ADDENDUM NUMBER 2

PROJECT: **Ke-nek Water Treatment Plant and Water Main**

PROJECT NUMBER: **CA 21-F05**

OWNER: **Yurok Tribe**

KE-NEK WATER TREATMENT PLANT AND KE-NEK WATER MAIN ROUGH FILTER DETAIL

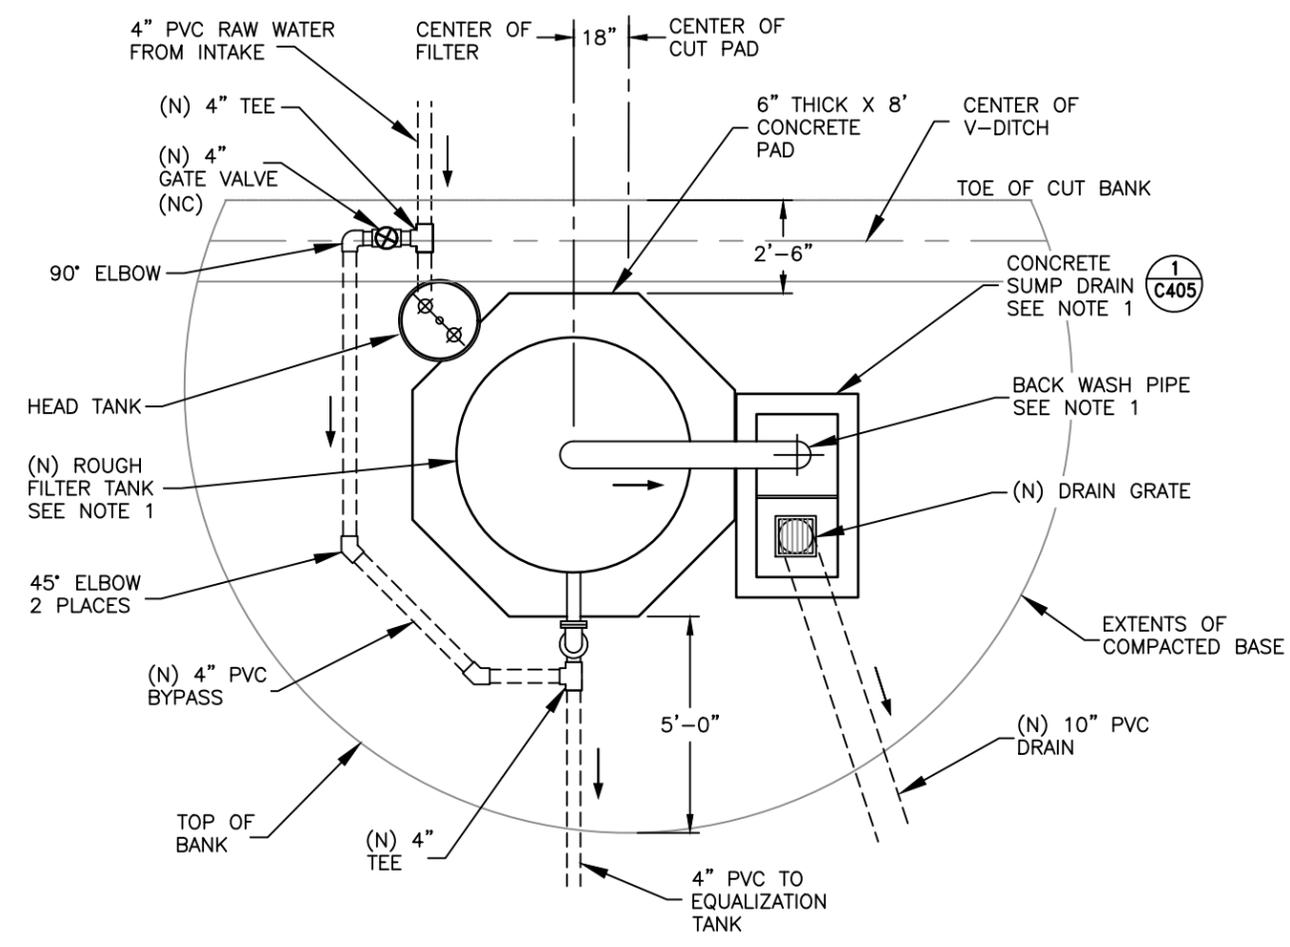
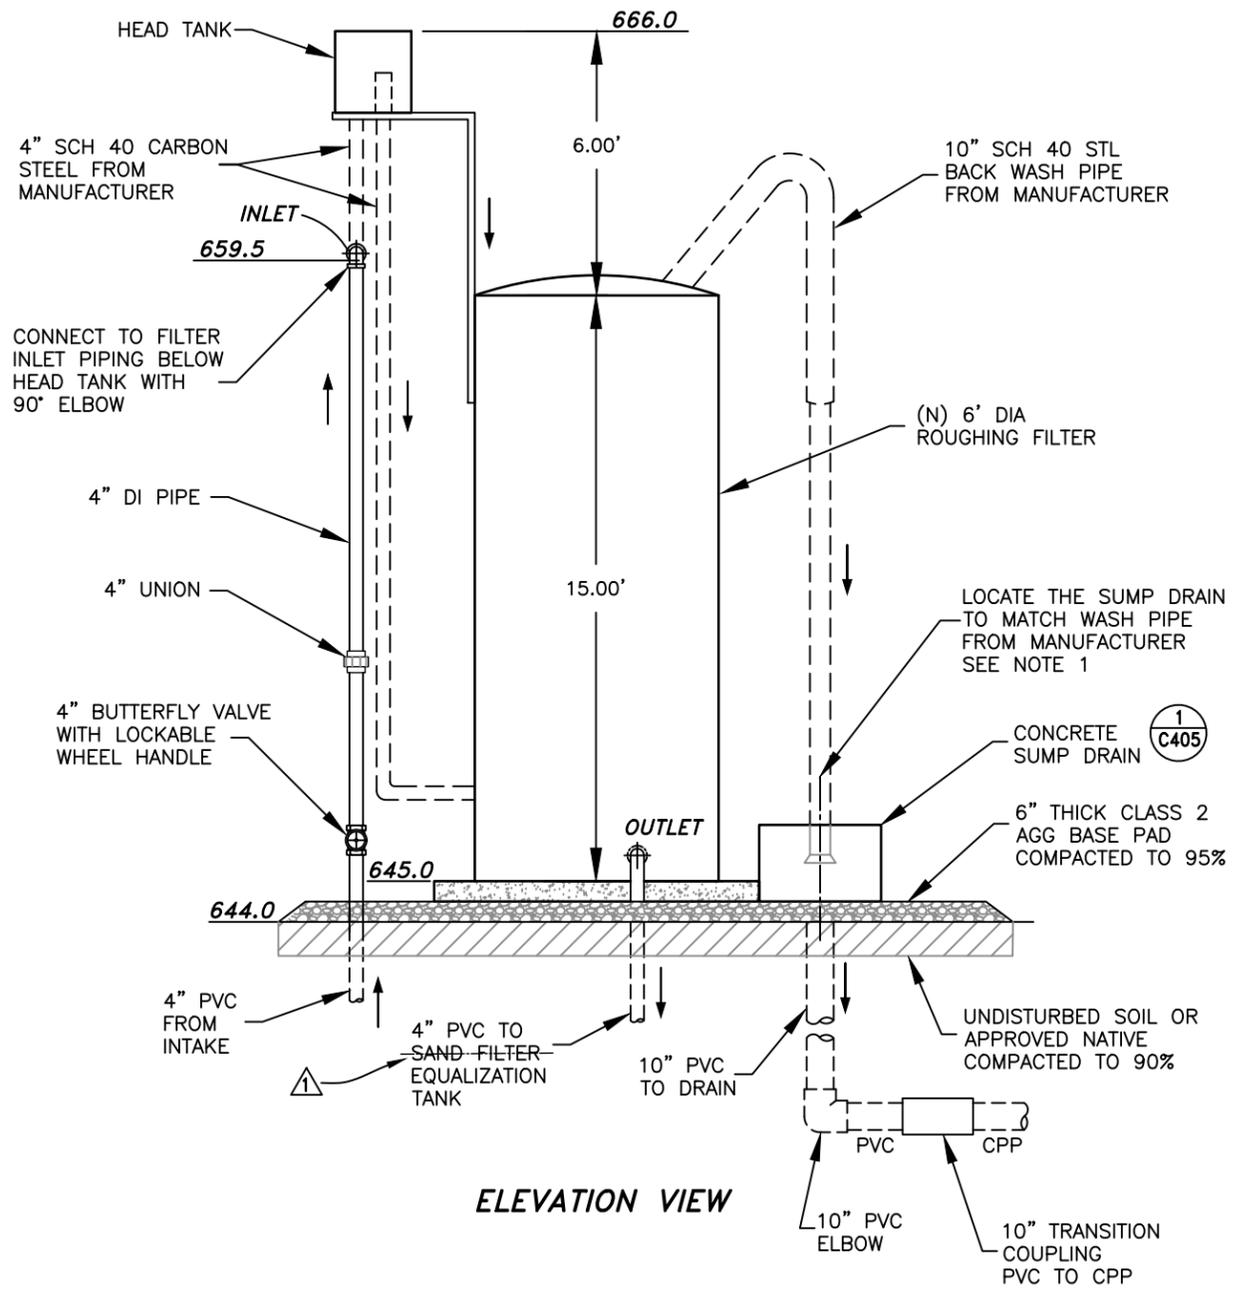
DRAWING C404 – Rough Filter Detail

Correction to destination of Rough Filter outlet piping. Detail noted “4” PVC to Sand Filter” on Elevation View. Changed to “4” PVC to Equalization Tank”
